Duane Arnold Energy Center
Docket No. 50-331
Renewed Op. License No. DPR-49

Response To Request For Additional Information Regarding Overall Integrated
Plan In Response To Order EA-12-051

NextEra Energy Duane Arnold, LLC's Response To Request For Additional Information Regarding Overall Integrated Plan In Response To Order EA-12-051

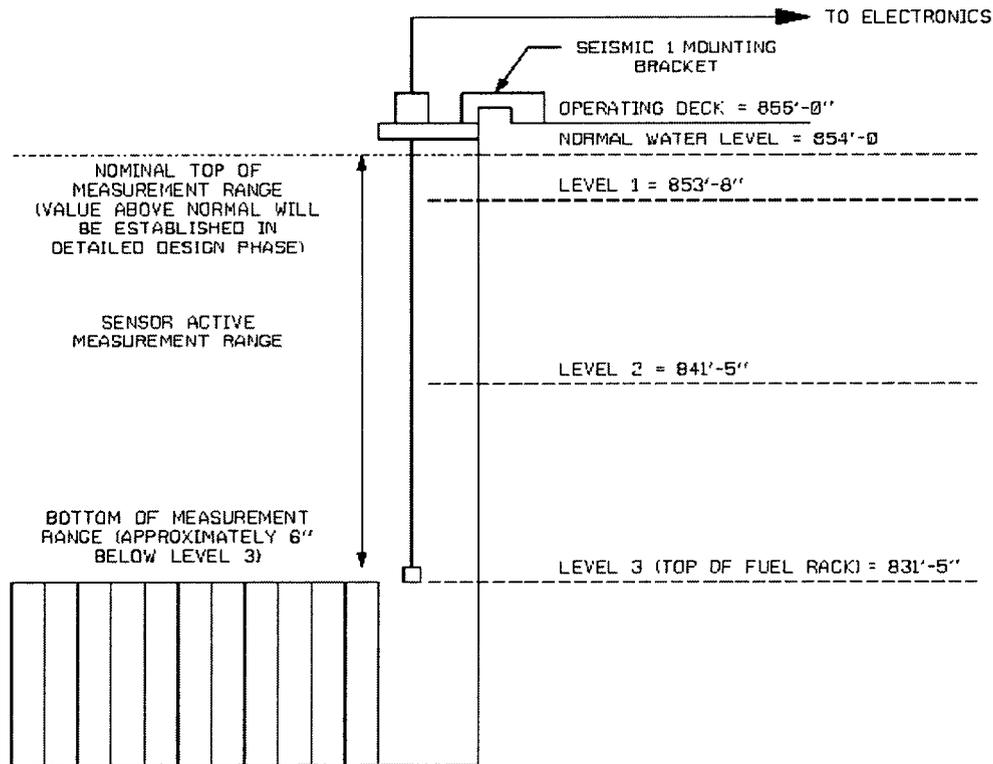
Please provide a clearly labeled sketch depicting the elevation view of the proposed typical mounting arrangement for the portions of instrument channel consisting of permanent measurement channel equipment (e.g., fixed level sensors and/or stilling wells, and mounting brackets). Indicate on this sketch the datum values representing Level 1, Level 2, and Level 3 as well as the top of the fuel racks. Indicate on this sketch the portion of the level sensor measurement range that is sensitive to measurement of the fuel pool level, with respect to the Level 1, Level 2, and Level 3 datum points.

The following sketch contains the information requested in RAI-1. Instrument uncertainty, which is yet to be determined, is not included in the elevation values for Levels 1 and 3.
